Memorandum

10 JULY 1968
EC9618/1576

SUBJECT: Cable short circuit in spacecraft 101 C²F²

Proposed

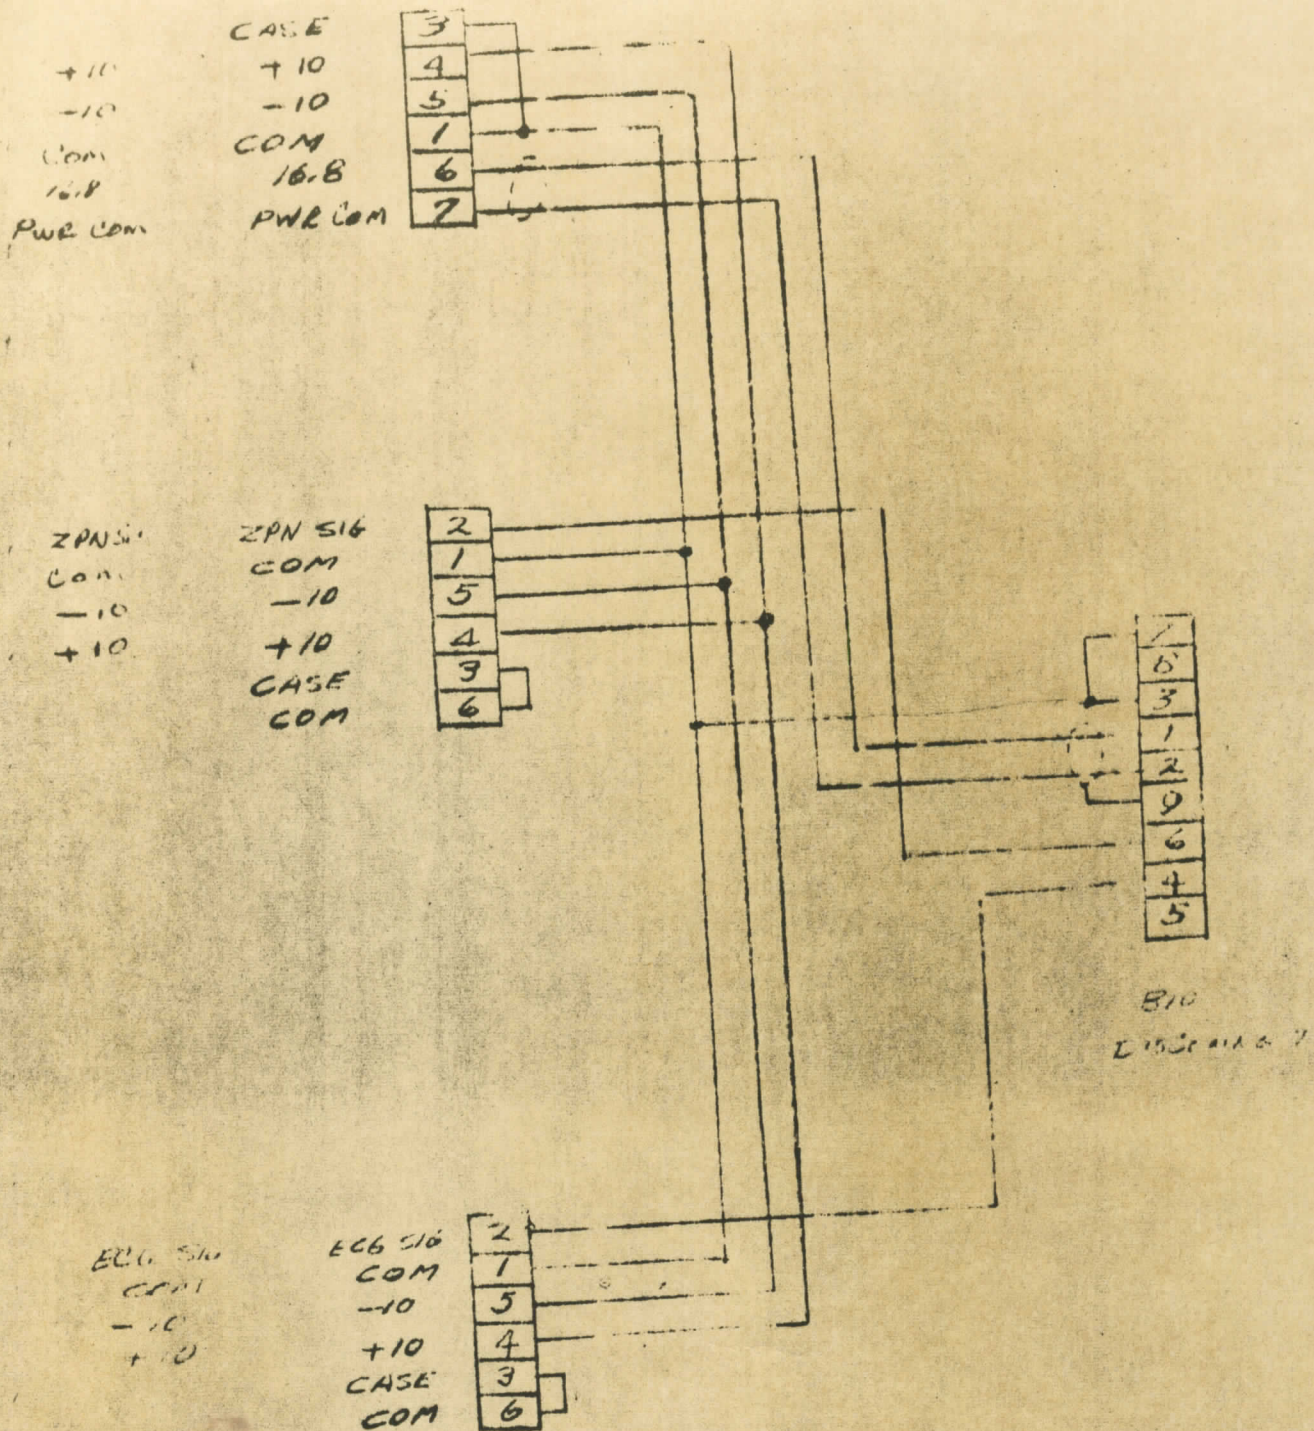
The shock hazard can be removed completely by adopting the "proposed" schematic. This will allow the astronaut's body to be at signal ground rather than shield ground. The "proposed" schematic is almost identical to the Block I with the exception that it will allow the use of Block II signal conditions and it will interface with the ILC suit furnished Block II torso harness.

Procurement action has been initiated to rebuild the Block II bioinstrumentation harness in order to remove the in-line filters that have been in these harnesses, and in light of recent decisions to use Block I and Block II signal conditions on the Block II program it would be no effort to wire the harness as the Block I harnesses are wired and eliminate the hazard completely.

Attention is made that the above change be incorporated into Block II harnesses. A proposed CCA is being prepared for the Apollo Support Branch Configuration Control Board.

EXISTING
 BLOCK II BIOLOGICAL UNIT

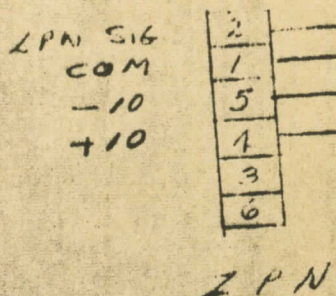
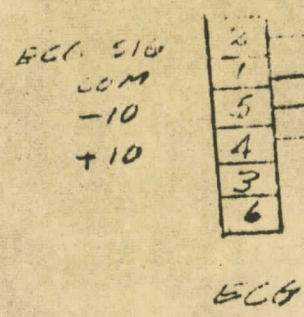
First the shock could only be caused by two separate malfunctions of the cable harness. Both of these malfunctions were evident in the cable. They were (1) the shield on the power lead was broken open and (2) the "hot" lead of the power was shorted to the shield past the opening on the "astronaut" side. As Block II bioharness is presently wired this shield lead is common throughout the system and terminates on the astronaut through the biomed electrode. When conditions exist such as described above, the bioinstrumentation is inoperative and allowing a potential of +28 VDC to be applied to the chest cavity of the astronaut. When this occurs, any time he touches ground potential he will feel a shock. This shock hazard exists any time the Block II bioinstrumentation harness, GFE, is used, but the likelihood of it occurring again are quite remote.
